# FACPAC Contract Change Order Supplemental Information Form (Ref# 64071)

Tier 1 Project: New West Middle School

PR 7 - Power to site signage

## Proposal Request #7

**SU-302**

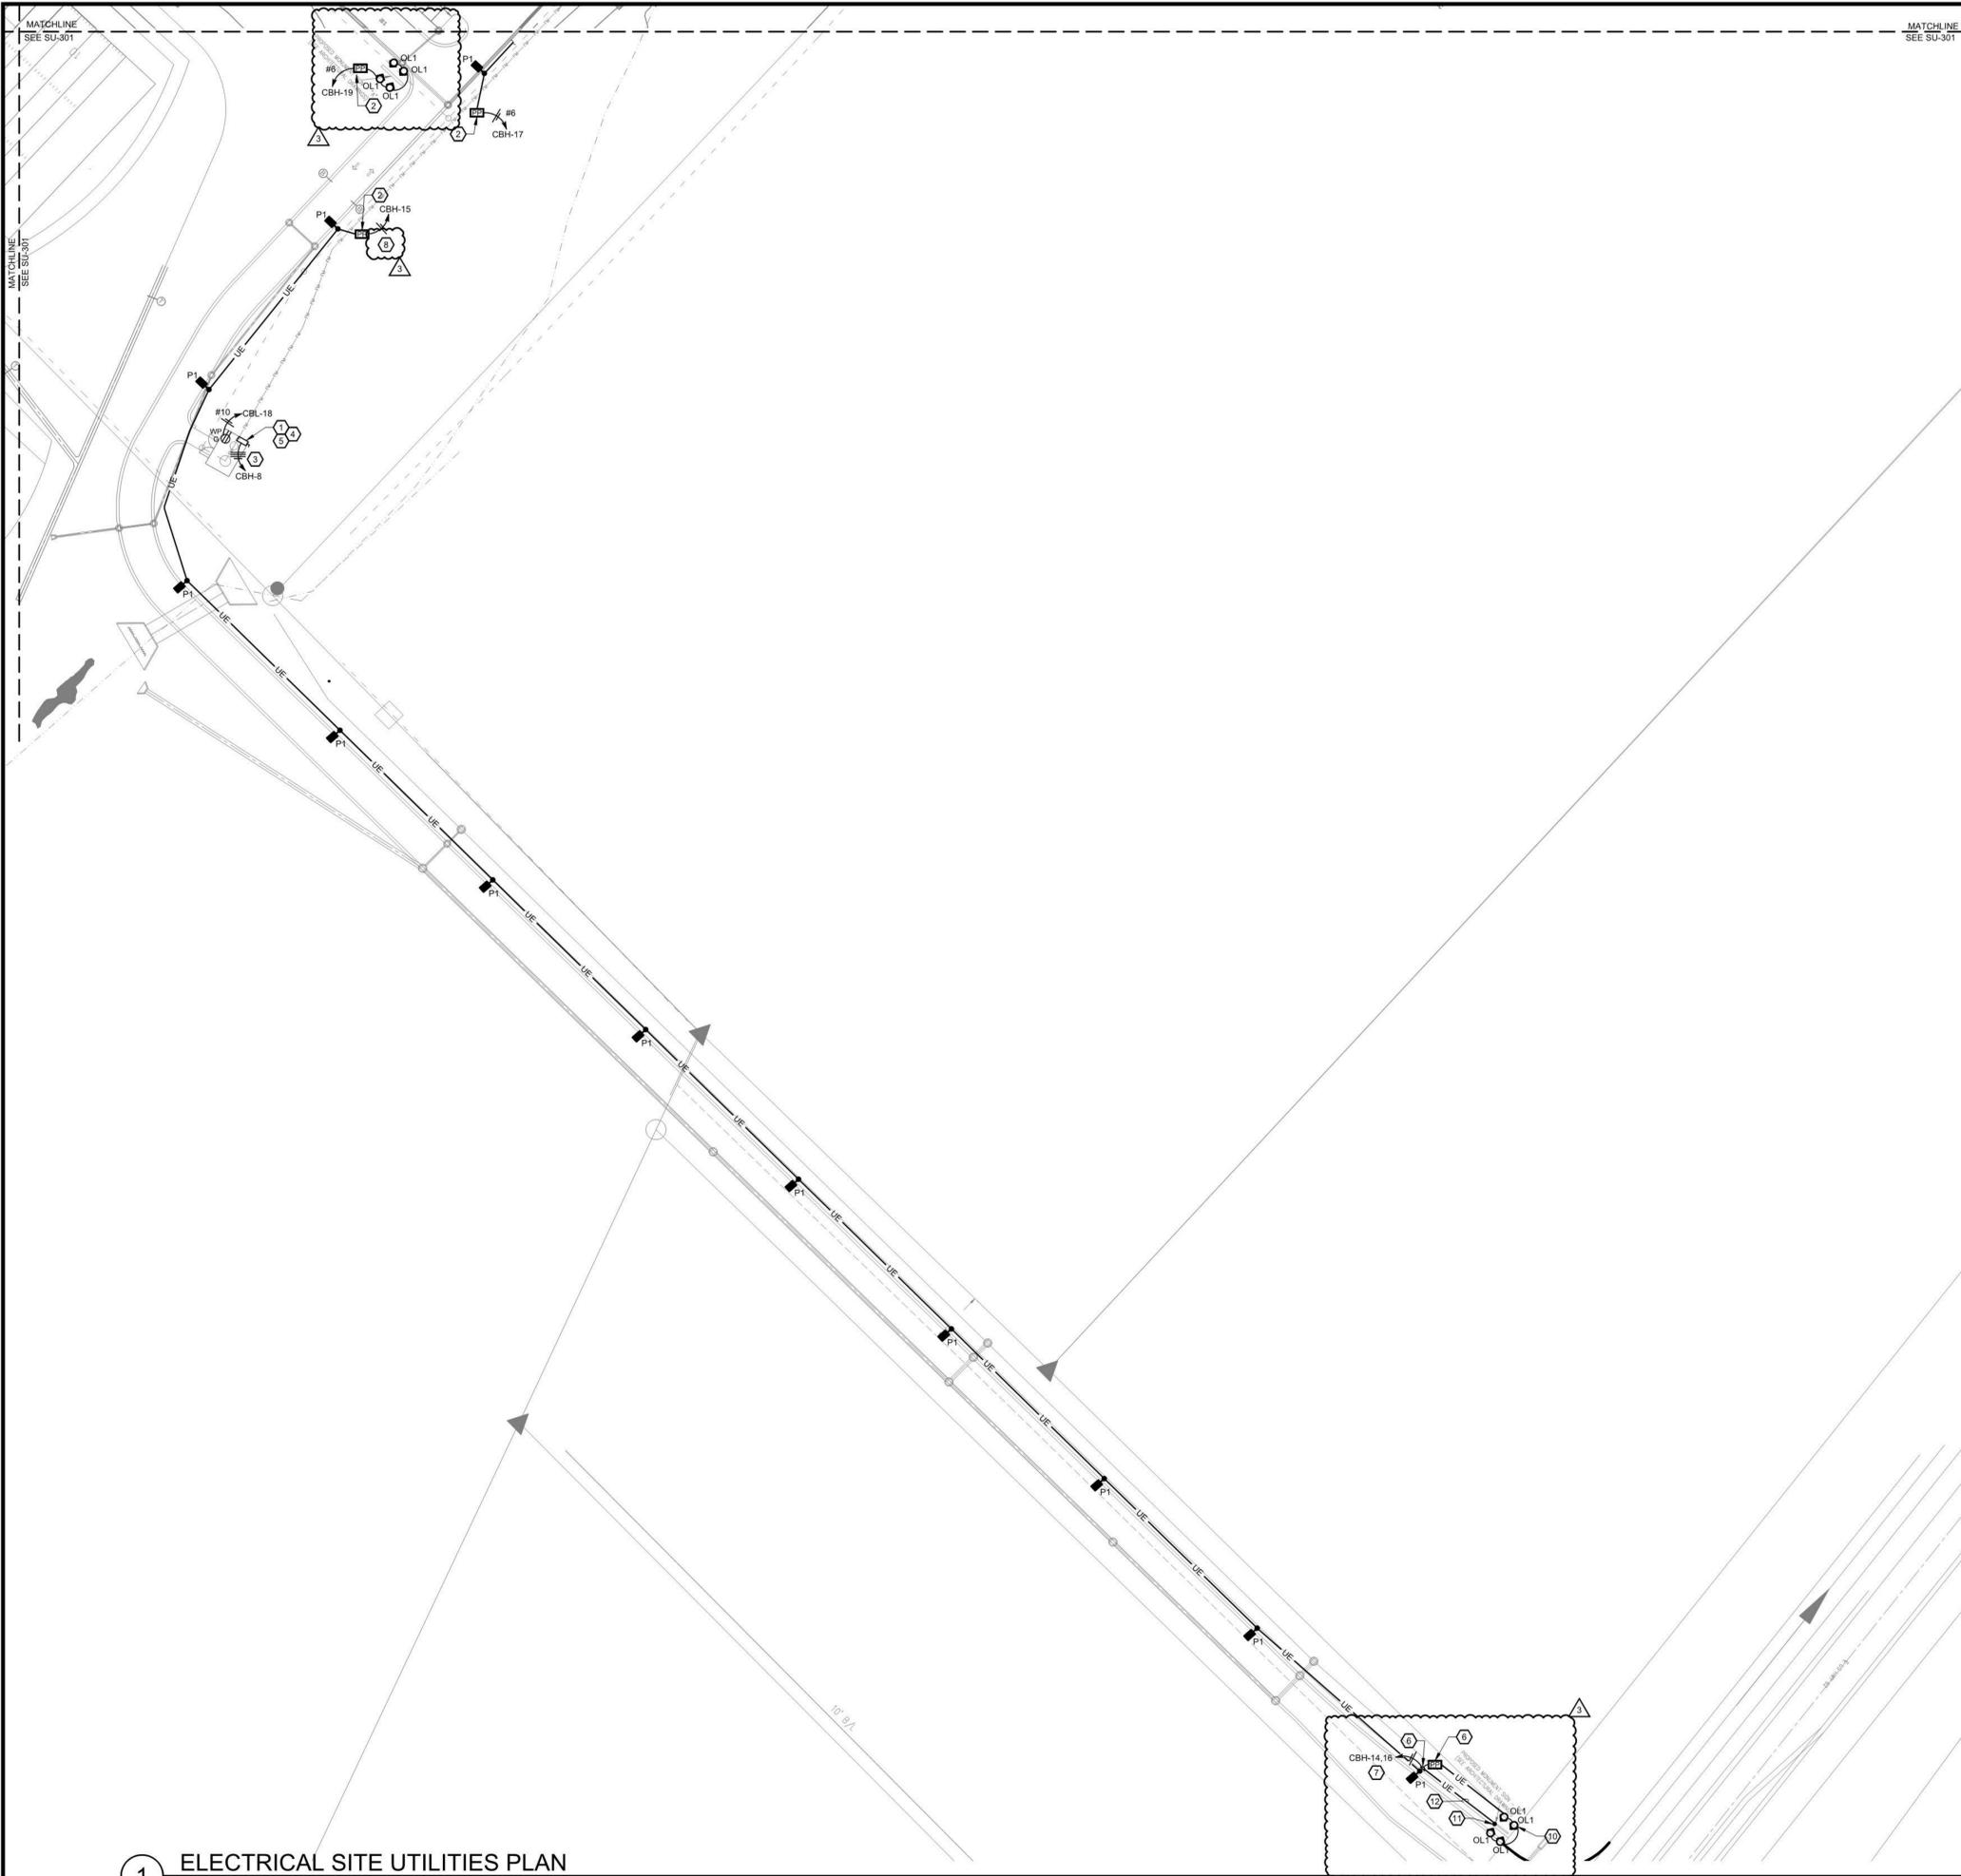
The owner would like to change the placement of the monumental signs on WHMS. The one that will hold the digital sign (A/A-380) will need to go out on 62. The tall one, (B/A-380) not made to hold the sign will need to be up next to the school. See attached for electrical revisions.

- Item 1: Refer to attached Drawing SU-302:
- Removed added power and fiber connection to digital signage in PR 7.
  - Revised sheet notes 6 and 7.
  - Added sheet notes 8-12.
  - Revised conductor size to pole light fixtures.
  - Added power connection to digital sign.
  - Added mini power zone.
  - Added wireless power pack.
- Item 2: Refer to attached Drawing E-615:
- Revised poles 14 and 16 in panel CBH.
  - Added panel schedule 'MINI POWER STATION'.
- Item 3: Provide submittal on mini power station for review prior to ordering.

1. PROVIDE 600V, 100A, 3-POLE FUSIBLE SAFETY SWITCH IN A NEMA 3R ENCLOSURE. FUSE SAFETY SWITCH AT SEA.
2. PROVIDE POWER PACK IN ROOM NEAR POWER SOURCE PANELBOARD.

3. PROVIDE #2, 1#10, AND 1-1/2" CONDUIT UNDERGROUND TO INDICATED PANELBOARD.
4. PROVIDE UN-STRUT STAND FOR MOUNTING OF ELECTRICAL EQUIPMENT.
5. PROVIDE CONNECTION TO LIFT STATION CONTROL PANELBOARD.

6. PROVIDE UNIT SUBSTATION, MINI POWER ZONE, 1 PHASE 5KVA, 480V PRIMARY, 120/240V SECONDARY, TYPE 3R, 18KA, WALL MOUNTED, BOLT ON BRANCH MOUNTED ON UNSTRUT STAND, SQUARE D MPUBSS40F. REFER TO TYPICAL FREESTANDING ELECTRICAL EQUIPMENT DETAIL FOR ADDITIONAL INFORMATION. REFER TO PANEL SCHEDULE ON E-615.

7. PROVIDE 2#6 WITH 1#8 IN SHARED CONDUIT WITH POLE LIGHTS.
8. PROVIDE 2#10, 1#100 IN 1" CONDUIT, SHARE CONDUIT WITH MINI POWER CENTER CONDUCTORS.
9. PROVIDE NUGHT RPP20 LOAD CONTROLLER WITH ETHERNET FAULT PROTECTION, 1VOLT AND REMOTE ANTENNA. PROVIDE NEMA 3R ENCLOSURE FOR HOUSING LOAD CONTROLLER. REFER TO TYPICAL FREESTANDING ELECTRICAL EQUIPMENT DETAIL FOR MOUNTING INFORMATION.

10. AIM FLOOD LIGHTS ON NON-DIGITAL SIDE OF SIGNAGE, TYPICAL OF FOUR(4).
11. PROVIDE POWER CONNECTION TO DIGITAL SIGN.
12. PROVIDE #4/2, 1#125 IN 3/4" CONDUIT FROM MINI POWER CENTER DIGITAL SIGNAGE THROUGH MONUMENT BASE.
